**SUNDRY NOTICES AND REPORTS ON WELLS**  
*Do not use this form for proposals to drill or to re-enter an abandoned well. Use form 3160-3 (APD) for such proposals.*

OXY USA Inc. respectfully requests the following bulk sundry changes to the approved APD's for the following wells:

- Salt Flat CC 20-29 Federal Com #32H - 30-015-45081
- Salt Flat CC 20-29 Federal Com #31H - 30-015-45080
- Salt Flat CC 20-29 Federal Com #33H - 30-015-45082

**OXY USA Inc. – Salt Flat CC 20-29 Federal Com 31H–32H-33H – Amended Drill Plan**

# 5/10M BOP Stack

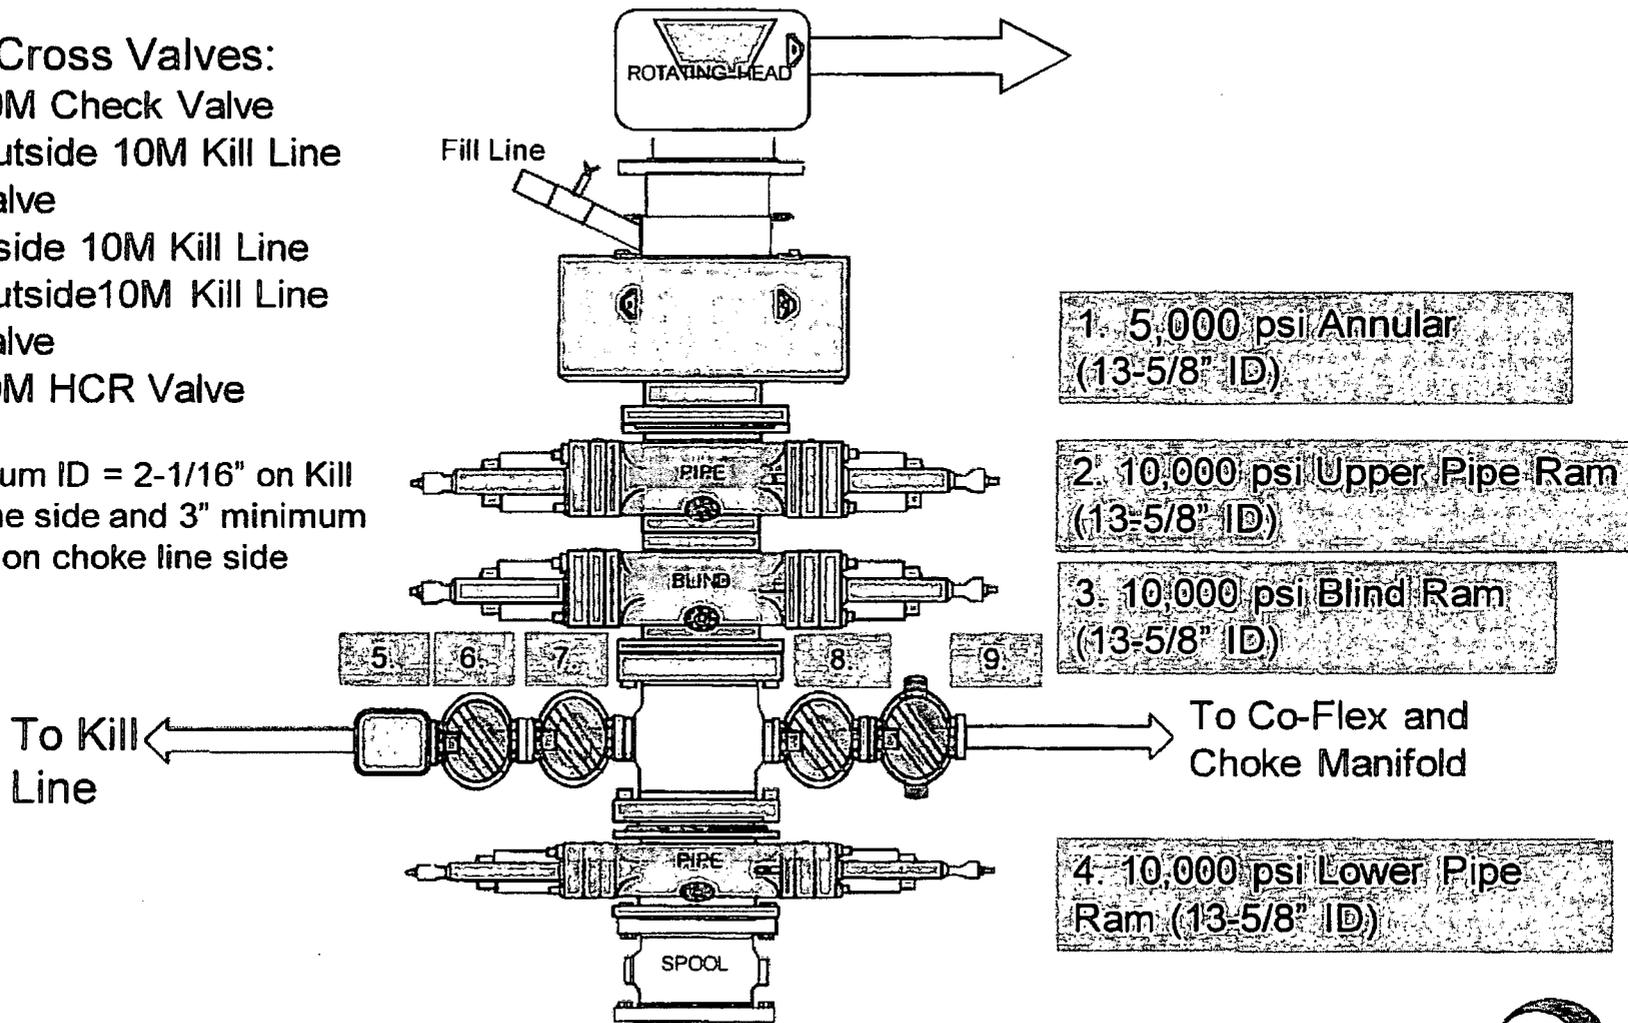
OXY will utilize a 5M annular with a 10M BOPE stack. The BOP/BOPE will be tested by an independent service company to 250 psi low and the high pressure indicated above per Onshore Order 2 requirements. The System may be upgraded to a higher pressure but still tested to the working pressure listed in the table above. If the system is upgraded all the components installed will be functional and tested.

General well schematic:

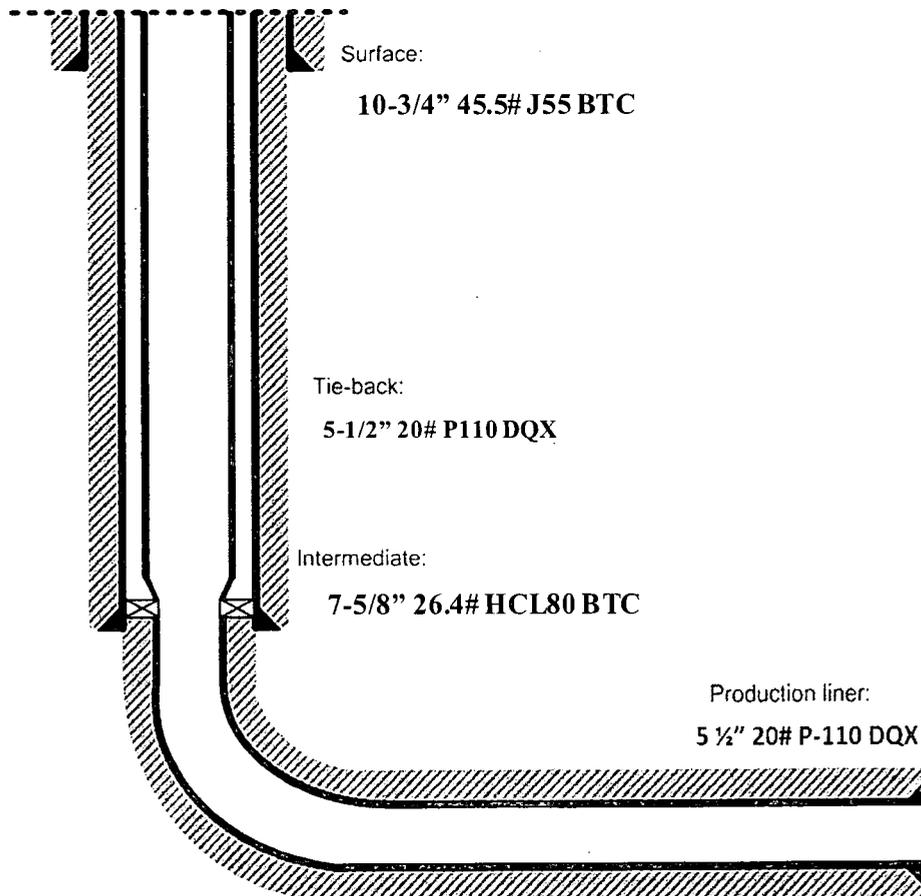
- Drill 14-3/4" hole x 10-3/4" casing for surface section. Cement to surface.
- Drill 9-7/8" hole x 7-5/8" casing for intermediate section. Cement to surface.
- Drill 6-3/4" hole x 5-1/2" liner for production section. Cement to top of liner, 100' inside 7-5/8" shoe.
- Release drilling rig from location.
- Move in workover rig and run a 5-1/2" 20# P110 DQX tie-back frack string and seal assembly (see connection specs below). Tie into liner hanger Polished Bore Receptacle (PBR) with seal assembly.
- Pump hydraulic fracture job.
- Flowback and produce well.

When a decision is made to develop a secondary bench from this wellbore, a workover rig will be moved to location. The workover rig will then retrieve the tie-back frack string and seal assembly before temporarily abandoning the initial lateral.
